RIDGWAY PLANNING COMMISSION

REGULAR MEETING AGENDA

Tuesday, November 30, 2021

To: Town of Ridgway Planning Commission
Cc: Preston Neill, *Ridgway Town Manager*
From: TJ Dlubac, AICP, *Community Planning Strategies, Contracted Town Planner*
Date: October 21, 2021
Subject: McIsaac Subdivision Planned Unit Development Preliminary Plan and Plat for October 26th PC Meeting

CURB & GUTTER PLAN & PROFILE
C4.0

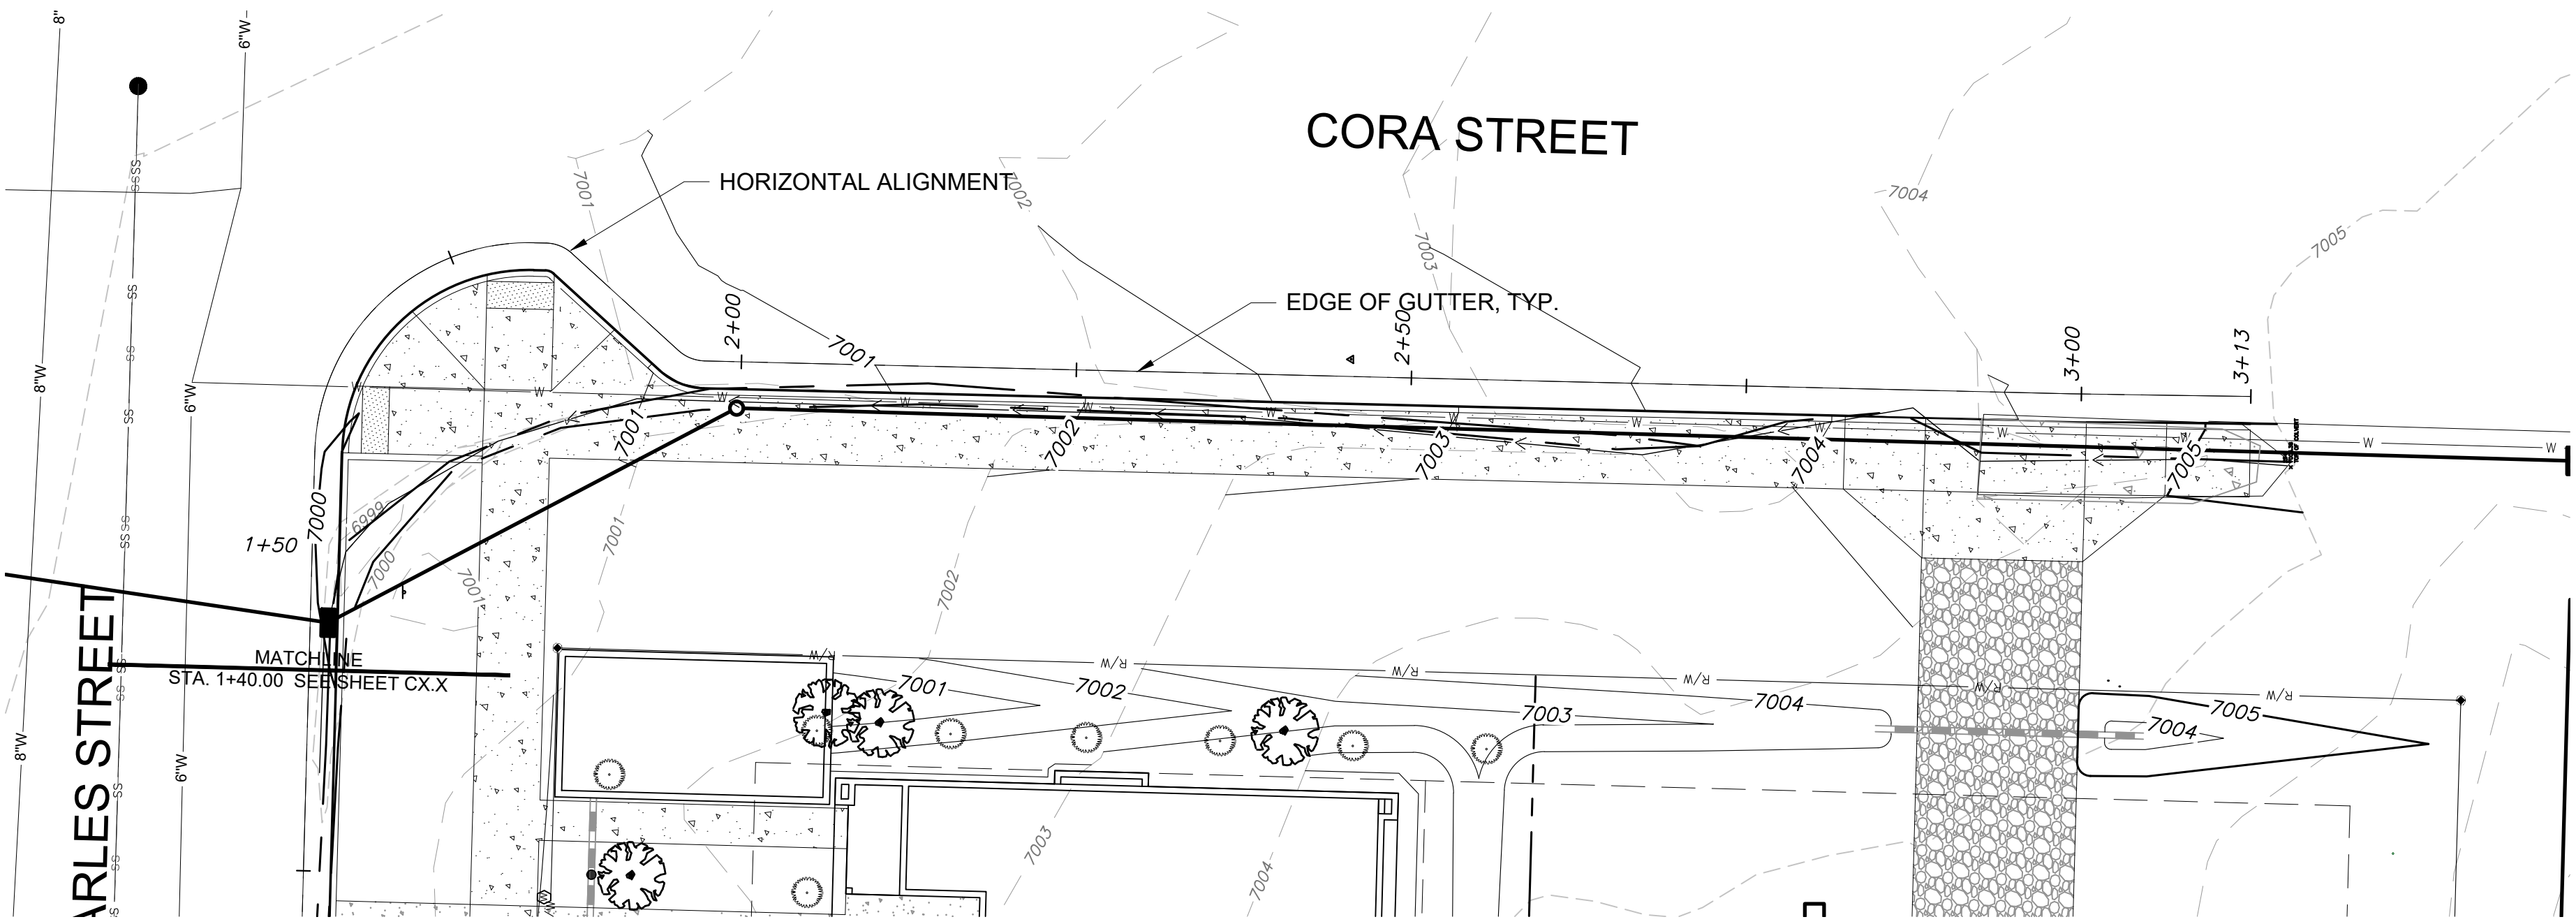
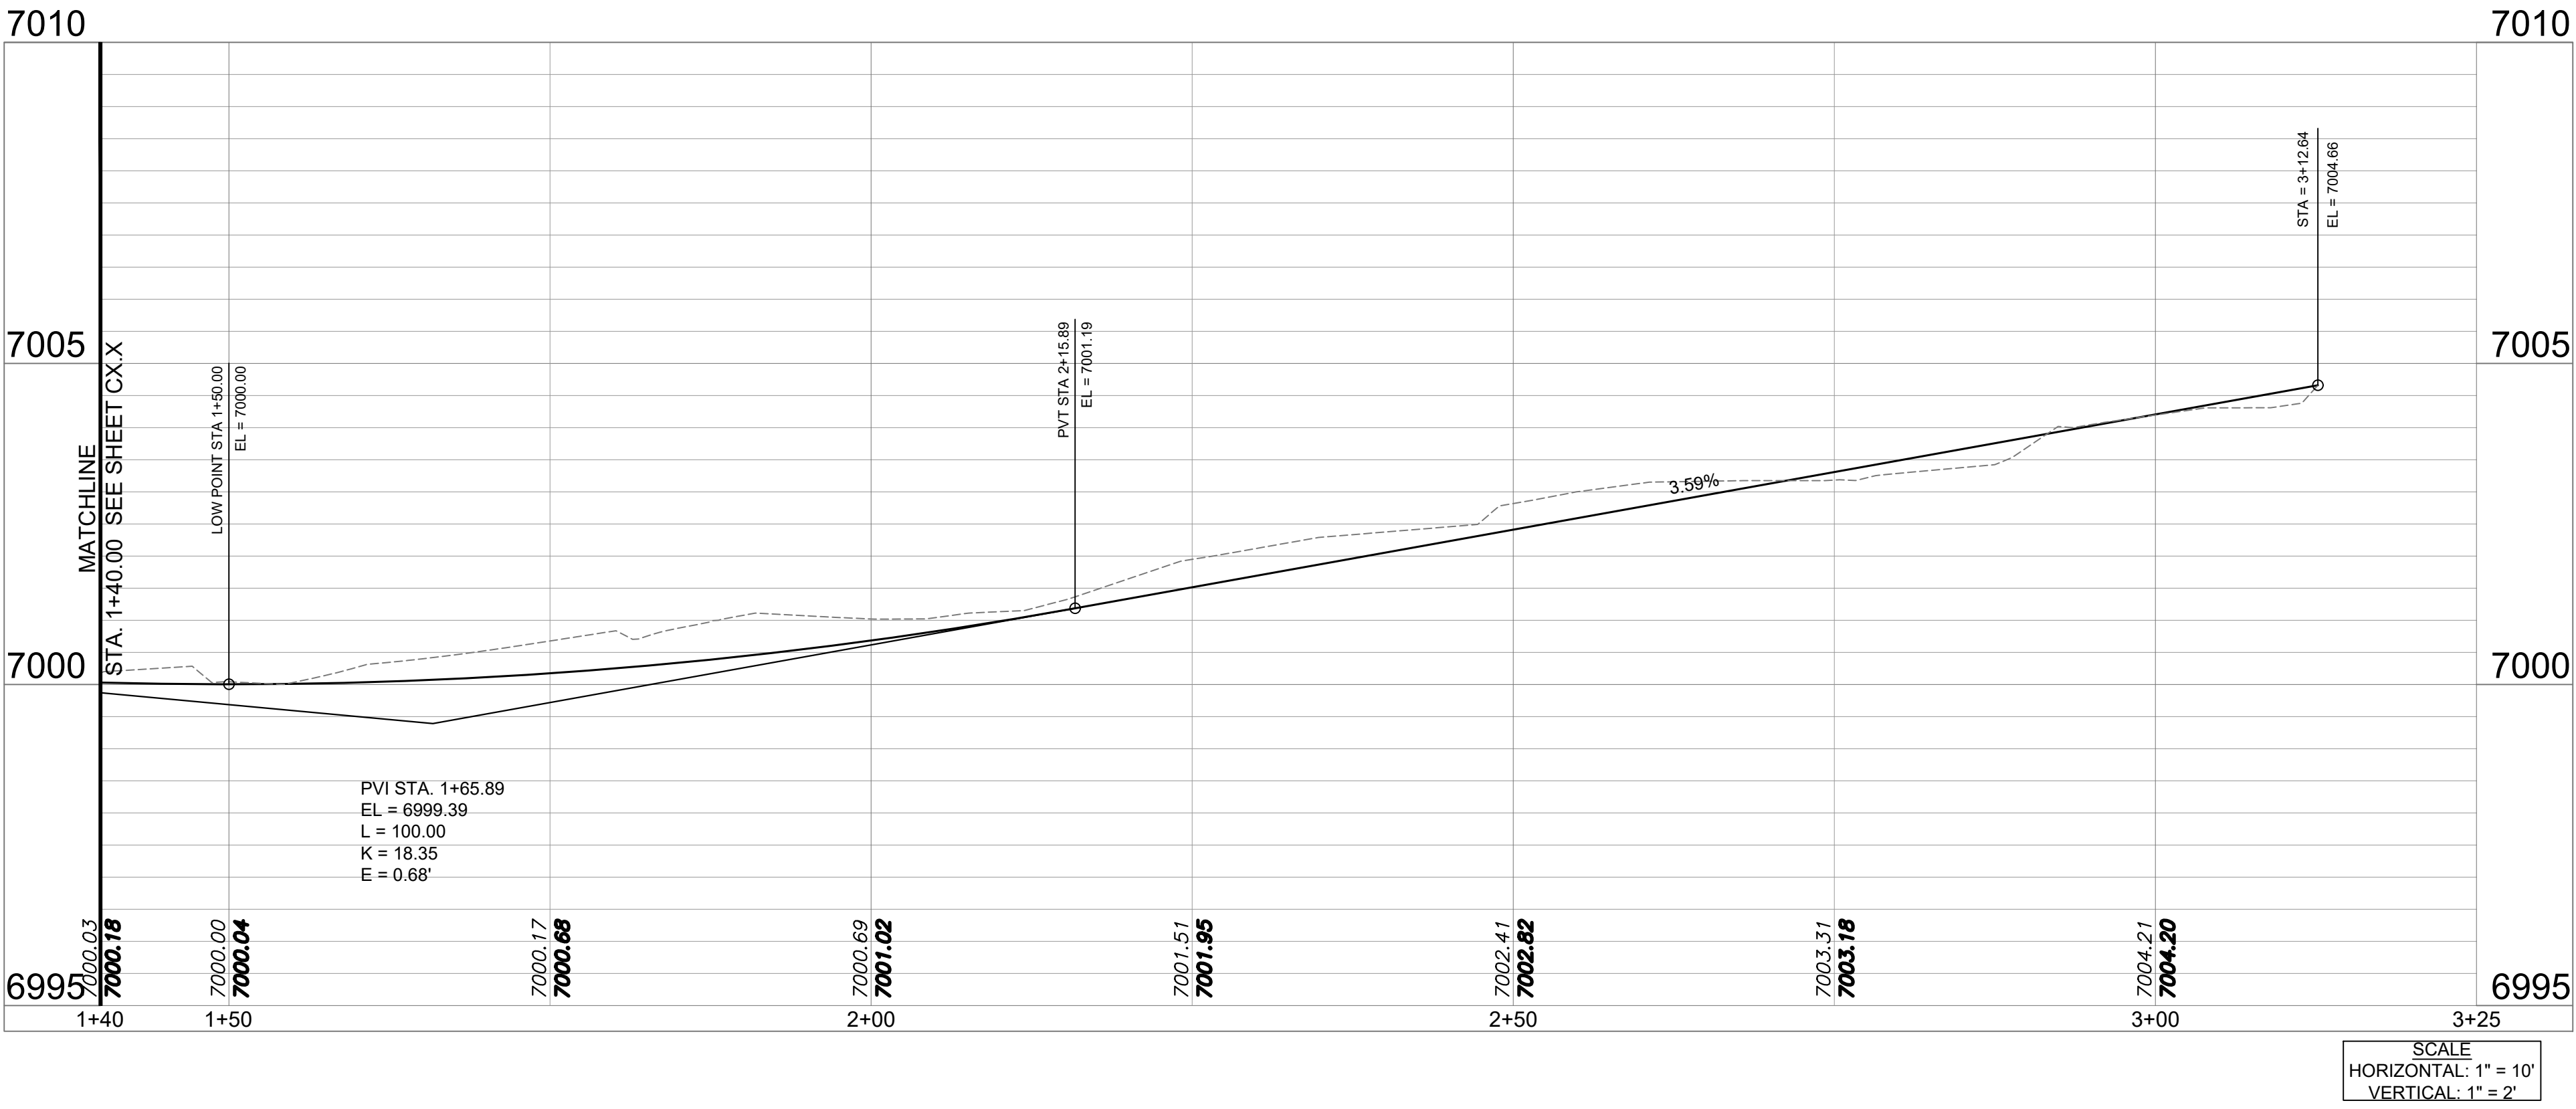
C4.0, 4.1			The profile on Charles should follow the C&G around the bulb out and likely needs coordinates and elevations are key points.	Not addressed	Horizontal alignment does follow the bulb. Call out added on sheet C4.2	
			We compared the slopes on Cora from the alley to Charles with the design drawings we shared with the developer and the developer's plans have flatter slopes. Please explain the differences.	Not addressed	Topo is based off of two separate surveys. Both showing approximately the same slopes.
